**2.3: LOCAL PLANNING POLICY – MODIFICATIONS TO THE DETAILED
AREA PLANS POLICY – CLYDESDALE PARK, MCKAIL**

Land Description	: Lots 201 – 210, 407 & 408 Donald Drive, Lots 211 – 216, 399 – 404 & 411 Engleheart Drive, Lots 217 – 239, 405, 406 & 410 Radiata Drive, Lots 240 – 252 Hankins Way & Lots 253 – 258 Withers Way, McKail
Proponent	: RPS Group
Owner/s	: Housing Authority, L Y Gilpin, M F & S D Russell, D V Main, A D & M J York & City of Albany (Vested Crown Land)
Business Entity Name	: N/A
Attachment(s)	: Draft modified Detailed Area Plan for Clydesdale Park : Proponent's justification for modifications to plan
Councillor Workstation	: Copy of OCM 20/11/2007 – Item 11.3.2 : Copy of OCM 19/02/2008 – Item 11.3.1 : Copy of OCM 21/09/2010 – Item 1.4 : Copy of OCM 19/04/2011 – Item 1.1 : Copy of OCM 20/11/2012 – Item 2.4 : Copy of submissions
Responsible Officer(s)	: Executive Director – Planning and Development Services (D Putland)

RE: PROPOSED DETAILED AREA PLAN – CLYDESDALE PARK ESTATE, ALBANY

DETAILED AREA PLAN R-CODE VARIATIONS

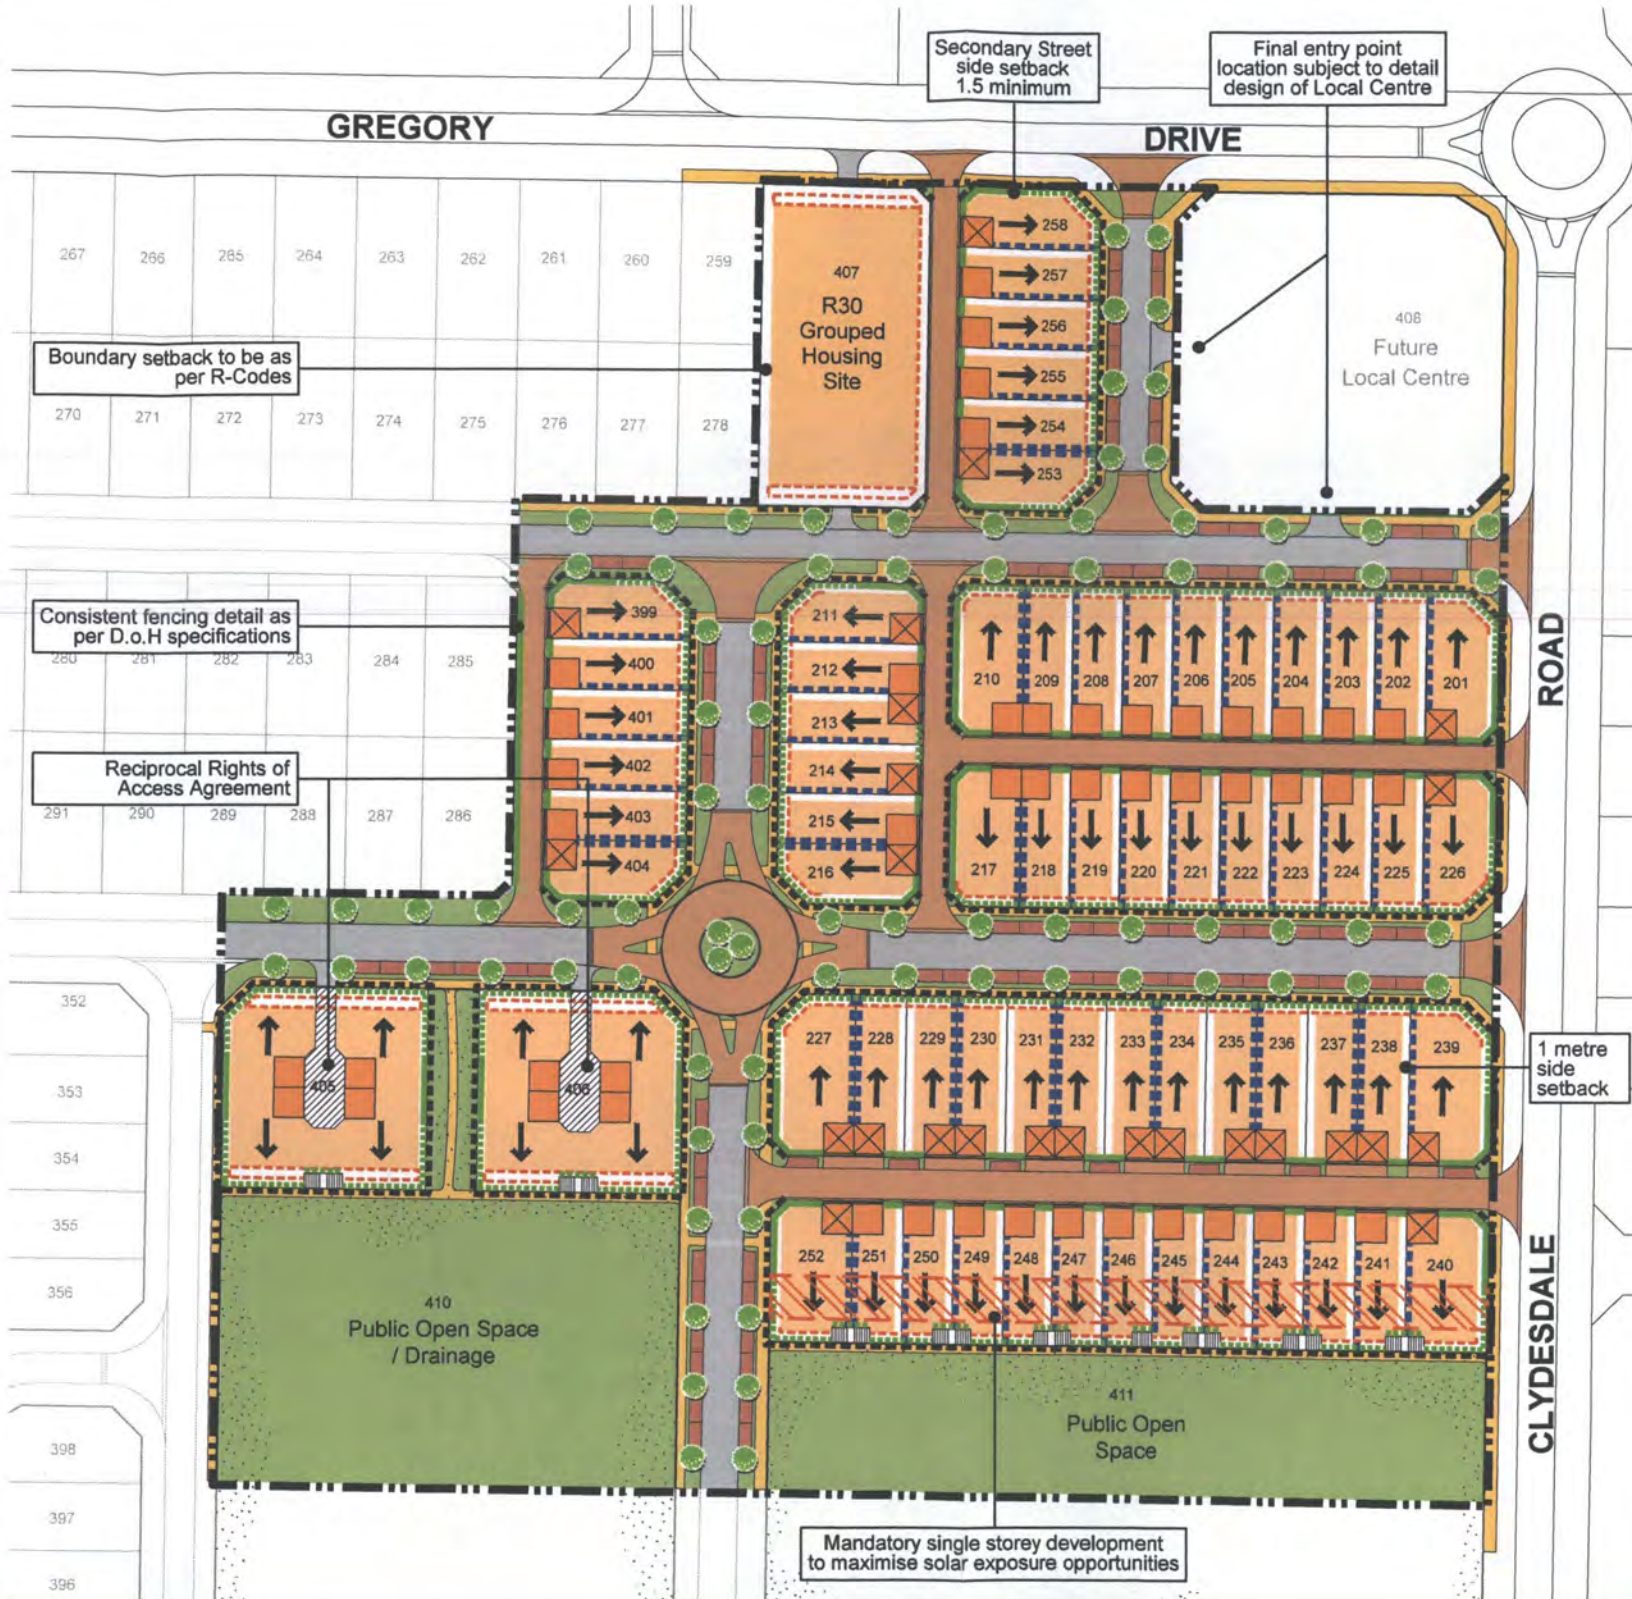
Relocate the position of the mandatory garage or carport locations for Lots 213 and 214 and illustrate a requirement for permeable estate fencing between the garage and the side lot boundary.

Acknowledging that through the removal of the mandatory requirement for studios above garages, RPS, in consultation with the Department of Housing, reviewed the opportunities for increased surveillance along the proposed laneways. It was identified that the proposed ‘T’ laneway would benefit from an increased level of surveillance, and therefore the above modification was undertaken.

Review and update all applicable rear / laneway setbacks given the amendments that have been made to the extent of the drainage easements along the rear of several of the lots within the Estate.

Since the time that the previous DAP was lodged, amendments have been undertaken to the drainage easements applicable to several of the lots (Deposited Plan 67389), and therefore the setbacks applicable to the lots under this Deposited Plan have been reviewed and updated accordingly, ensuring that the rear / laneway setbacks are consistent with the amended easement widths.

Include a notation on Lot 407 stating that the ‘Boundary setback to be as per R-Codes’.

The previous DAP submitted illustrated a red-dashed line along the boundary of Lot 407, which was not applicable as such a line is only applicable for the primary street or POS setback. Therefore, the DAP has been updated to remove this line and to include a notation requiring that the boundary setback of this grouped housing site be as per the requirements of the R-Codes.

- Single residential dwellings on corner lots are encouraged to incorporate an independently occupied studio above the garage to assist in providing surveillance of the laneway.
